**ADDENDUM  
NO. 2**

**November 4, 2021**

**Portage Township School - Bid Package #2  
PHS Learning Lab, Elementary Schools Media Centers, and Office Renovation  
Portage IN, 46368**

## ADDENDUM NO. 2

ADDENDUM NO. 2	DATE 11/1/21	ADDENDUM DRAWING NO. MEDIA 4.1A
PORTAGE TOWNSHIP SCHOOLS LEARNING LAB, MEDIA CENTERS, OFFICE AND OFFICE PROJECT PORTAGE, INDIANA	DRAWING SHT. 4.1	<b>ALLIANCE</b> ARCHITECTS 929 Lincolnway East, Suite 200   South Bend, Indiana 46601

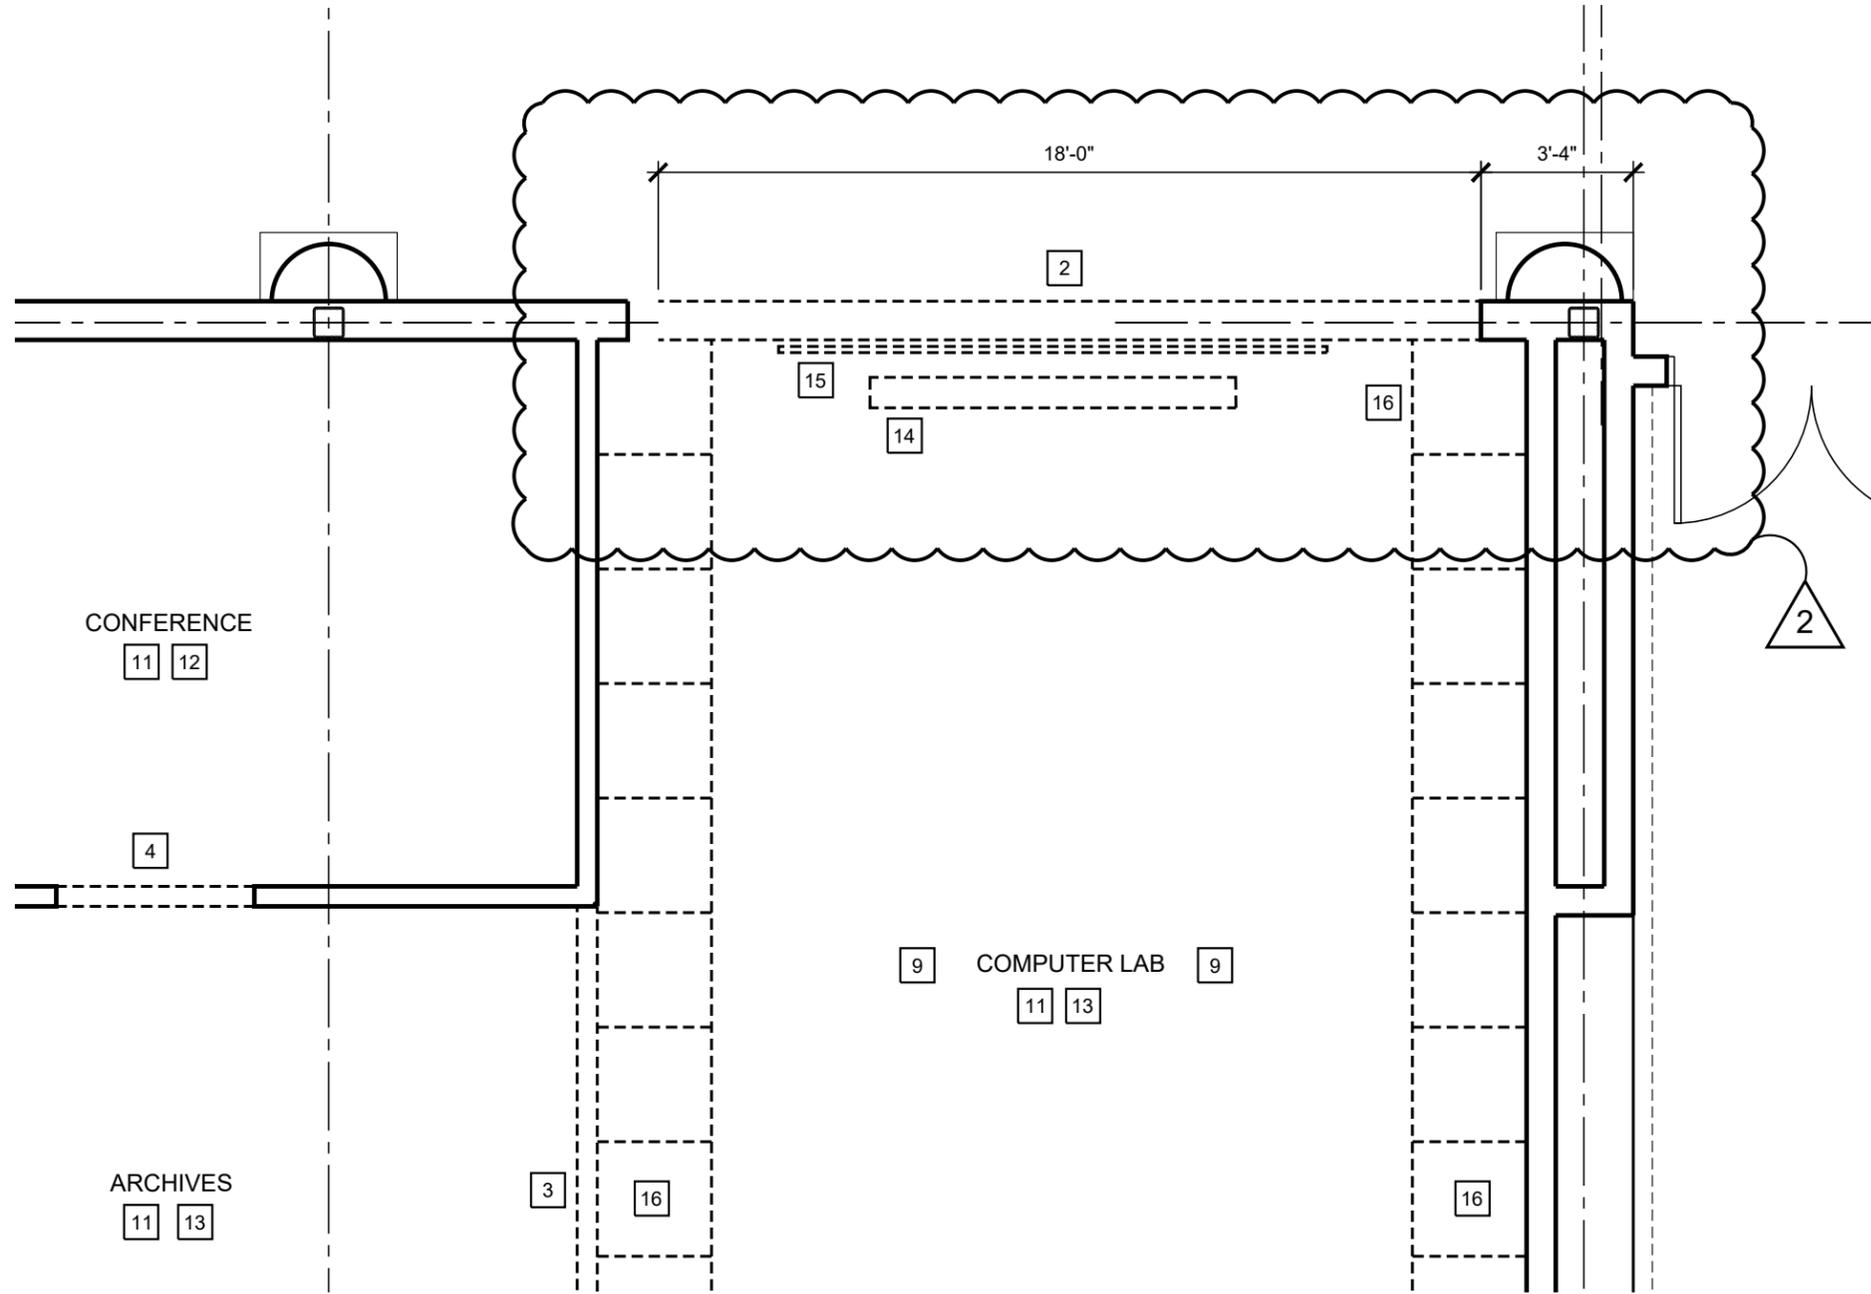
- 2) Revise the Floor Plan as shown on Addendum Drawing No. MEDIA 4.0B, dated 11/1/21.
21. **DRAWINGS**; Sheet No. MEDIA 4.1; WEST ELEVATION 4/4.1: Replace this elevation with Addendum Drawing No. MEDIA 4.1A, dated 11/1/21.

ADDENDUM DRAWING NO. OFFICE D1.0A

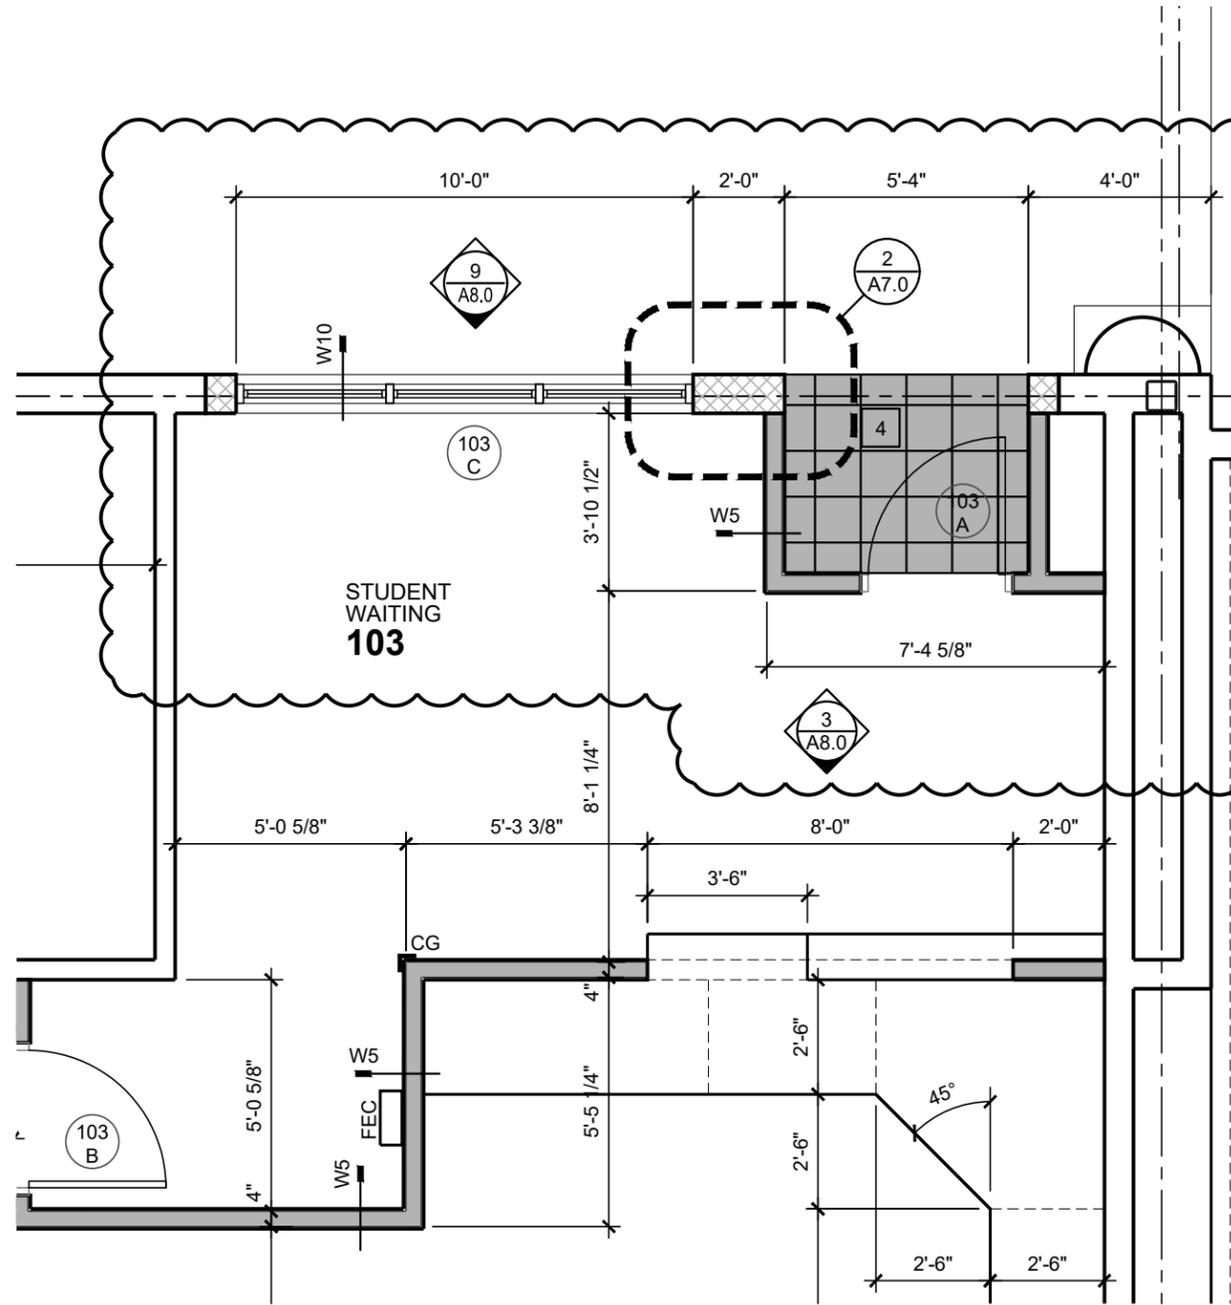
26. **DRAWINGS**; Sheet No. OFFICE D1.0; DEMOLITION PLAN: Revise the dimensions indicating the extent of wall removal as shown on Addendum Drawing No. OFFICE D1.0A, dated 11/1/21.

ADDENDUM DRAWING NO. OFFICE A7.0A

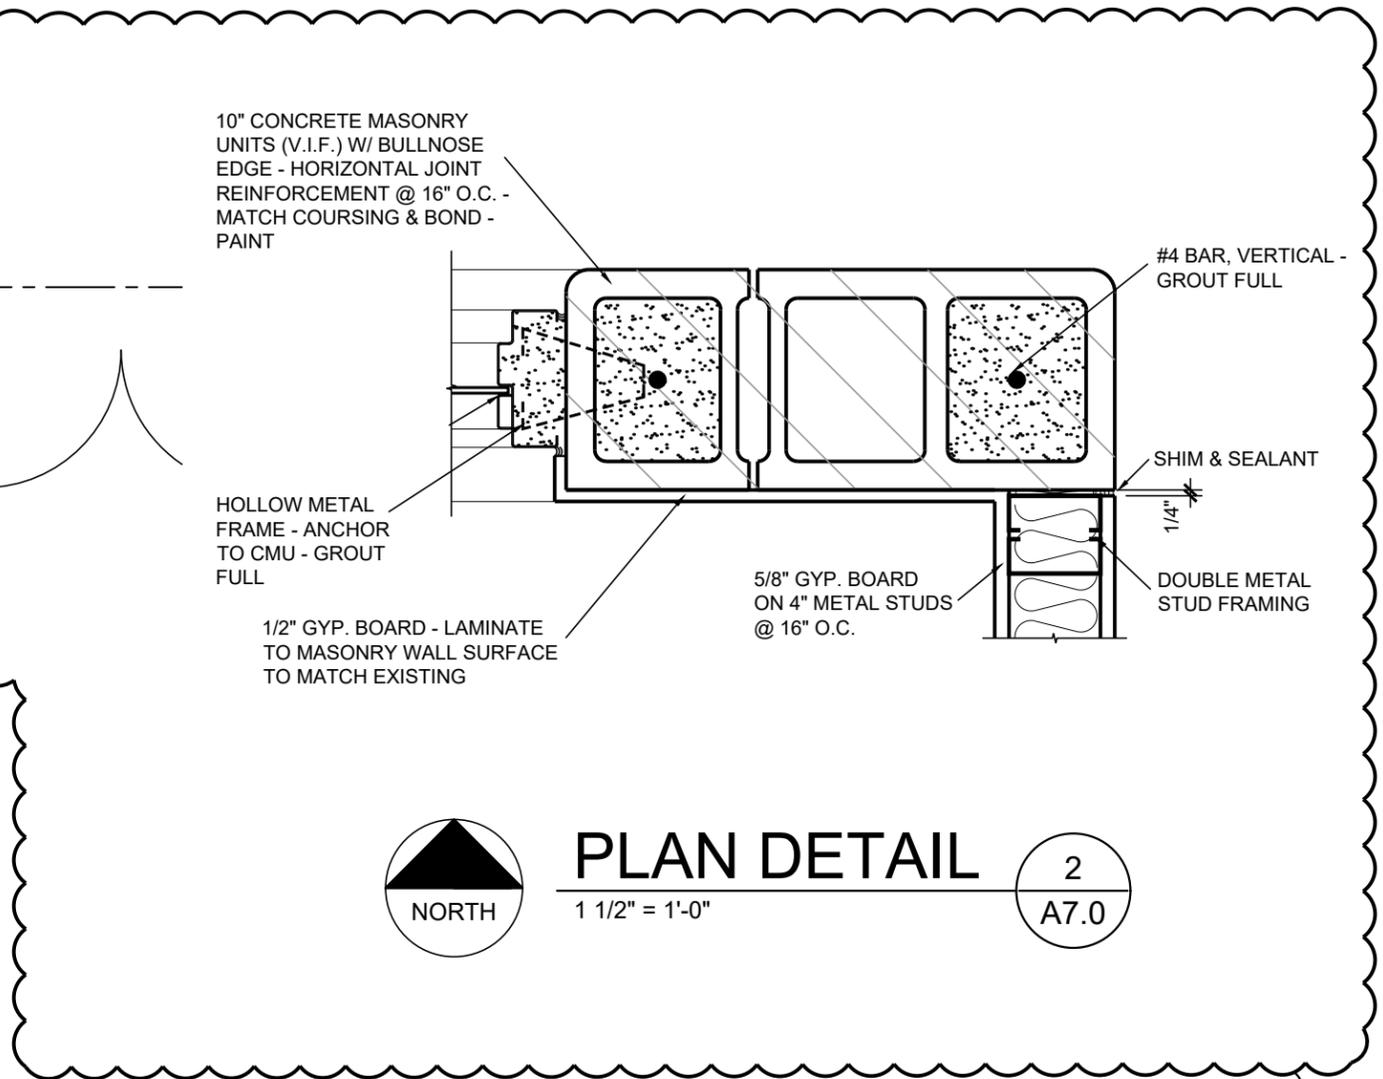
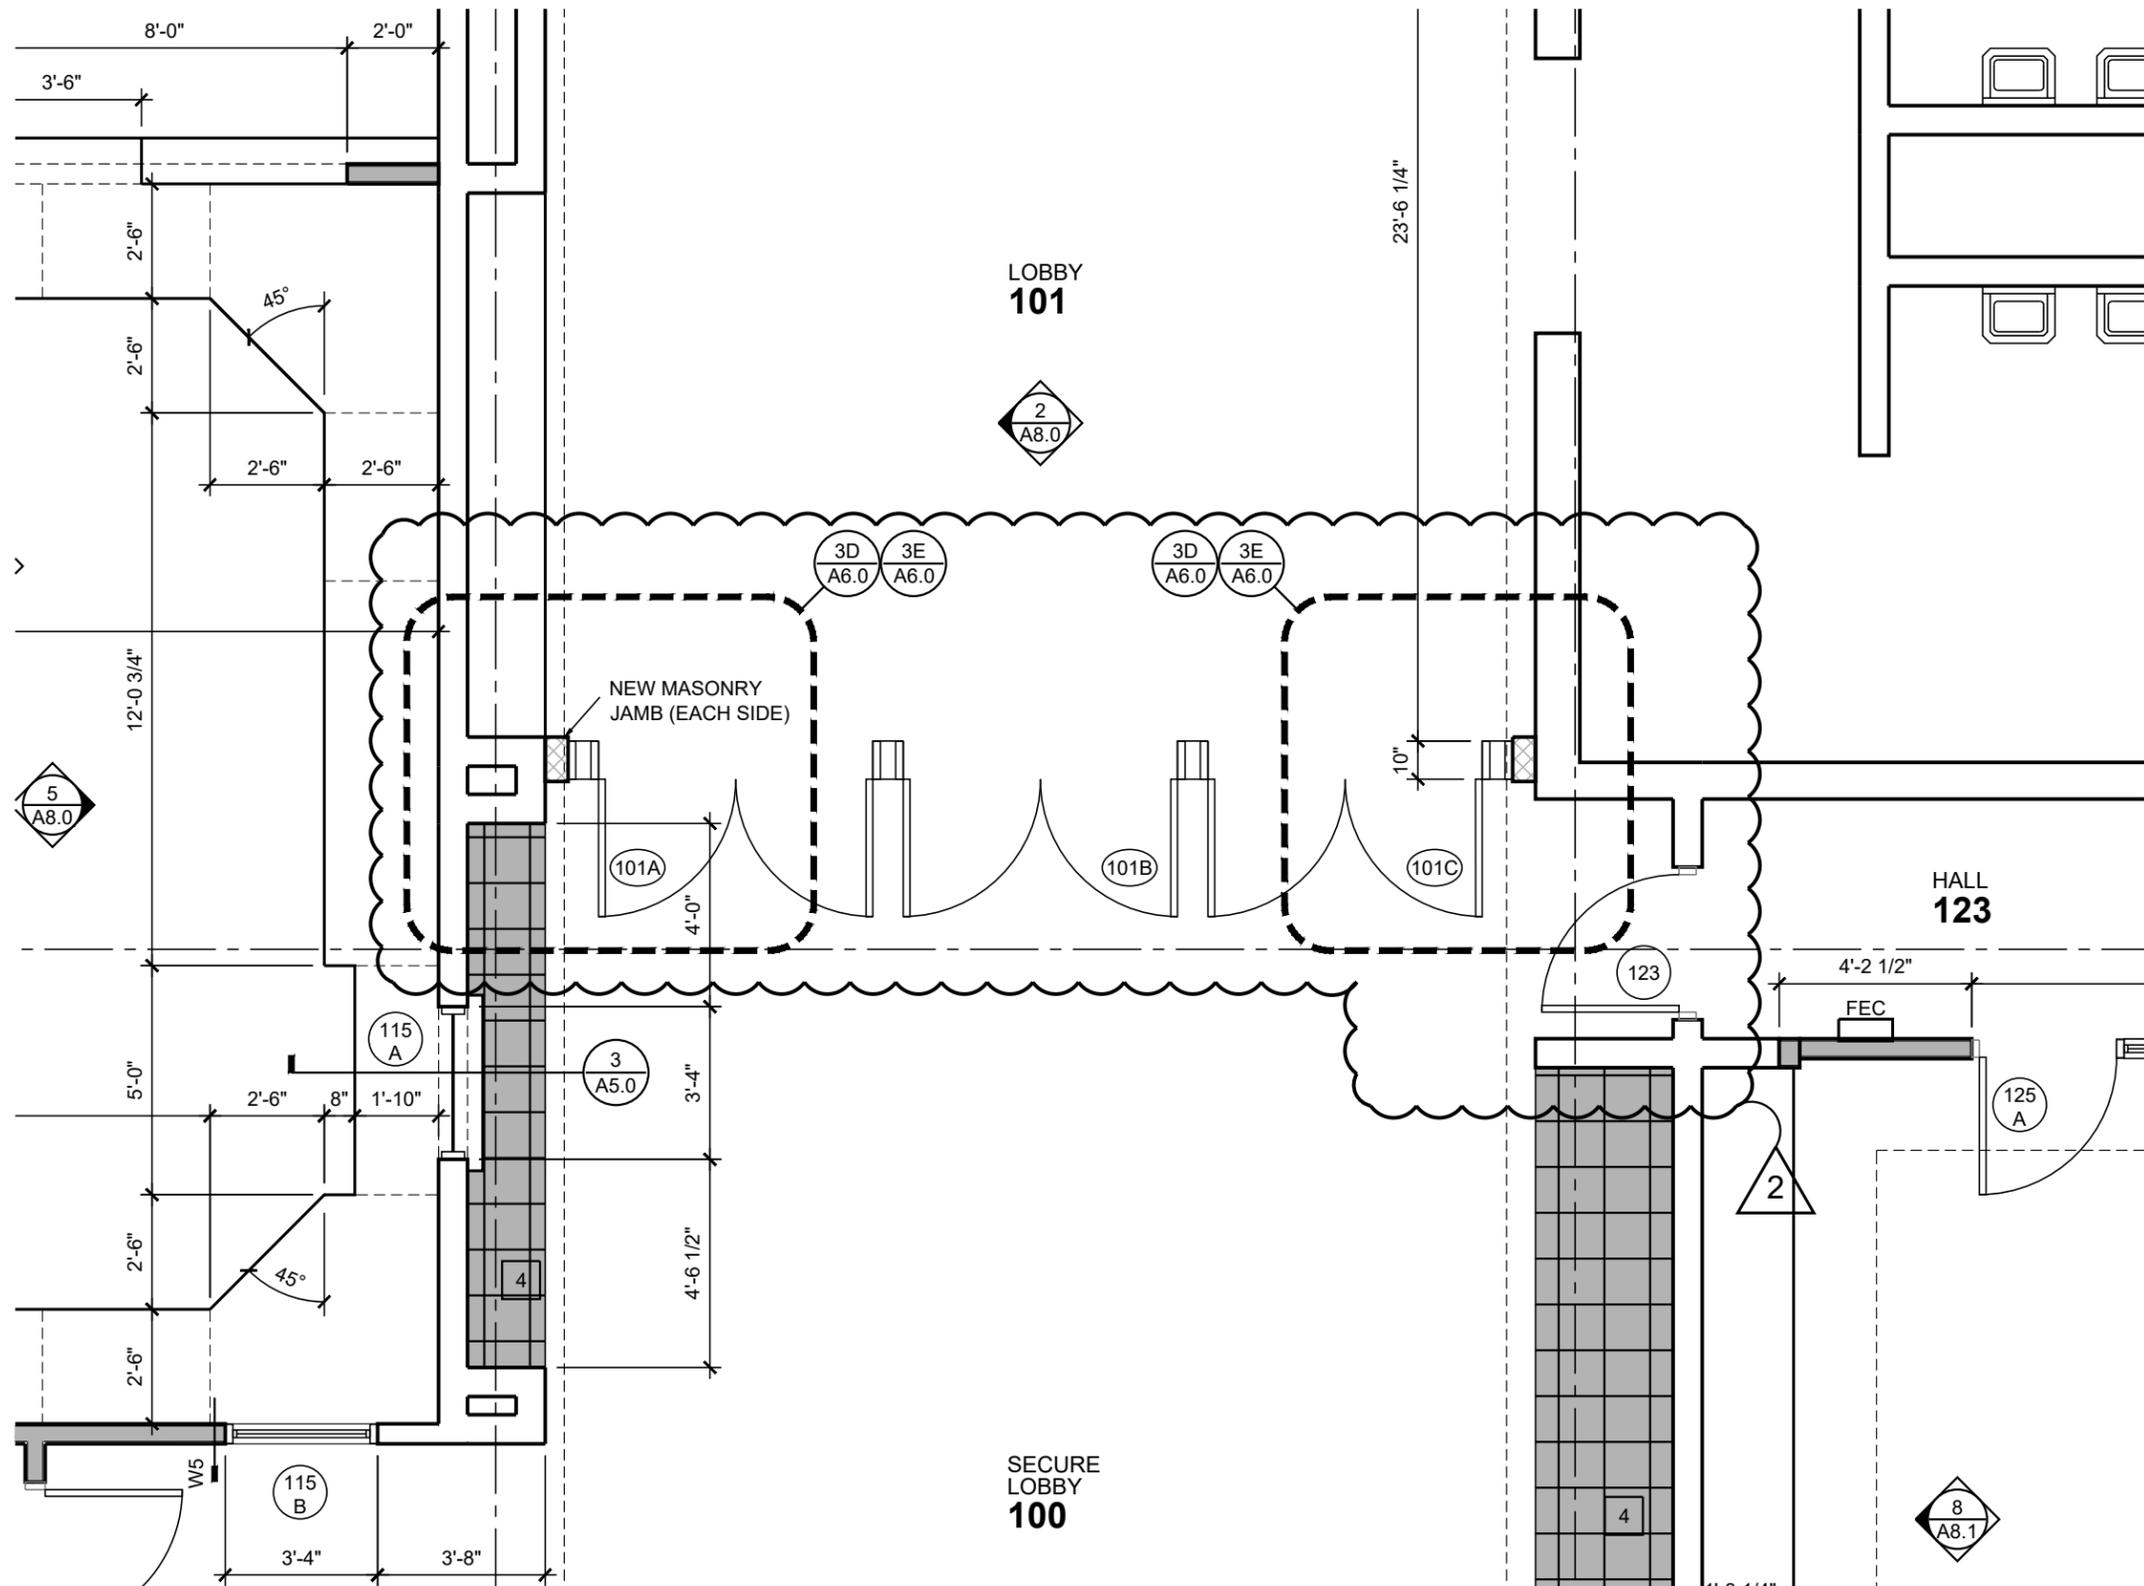
- a. Revise ENLARGED PLAN 1/A7.0 as shown on Addendum Drawing No. OFFICE A7.0A, dated 11/1/21.
- b. Revise ENLARGED PLAN 1/A7.0 as shown on Addendum Drawing No. OFFICE A7.0B, dated 11/1/21.
